ADDENDUM 1
Date of Addendum: 12/20/21

NOTICE TO ALL VENDORS

Six Individual Rooms

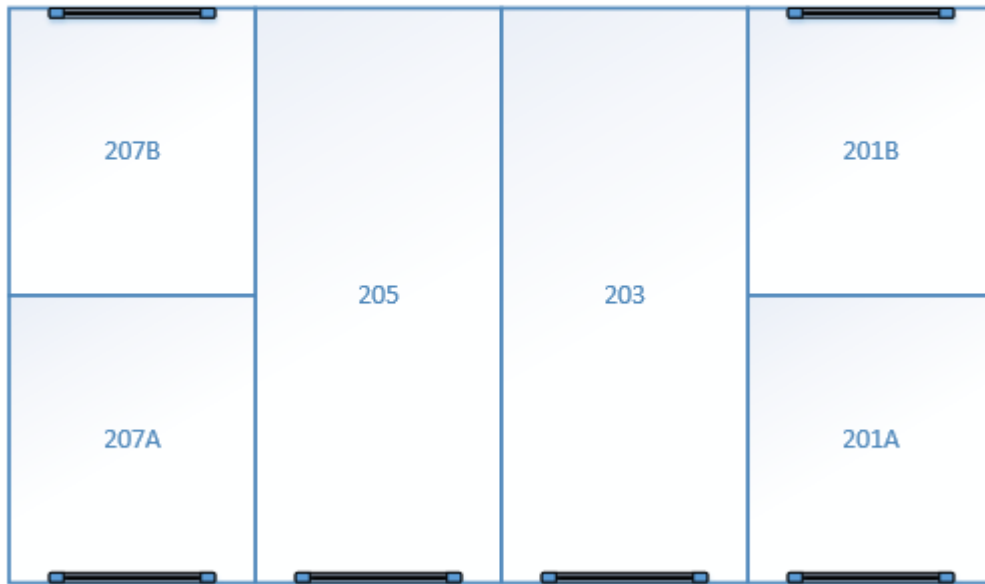
1.3	<p><u>Question:</u> Can you provide the various sub room combinations for dividing and combining the audio systems for the CSC ballrooms?</p> <p><u>Answer:</u> Refer to attached drawings.</p>

1.4	<p><u>Question:</u> How is the video to be routed and displayed during the various room combinations?</p> <p><u>Answer:</u> Refer to attached drawings.</p>

1.6	<p><u>Question:</u> How is the videoconferencing to operate when rooms are in the various combine</p>

<p>modes?</p> <p><u>Answer:</u> Refer to attached drawings.</p>
1.7	<p><u>Question:</u> Does LCCC have Zoom room licenses and/or connectors for any of the rooms requiring videoconferencing?</p> <p><u>Answer:</u> No Zoom Rooms licenses. User licenses for each user. No Connector Licenses</p>

Drawing of Room Layouts
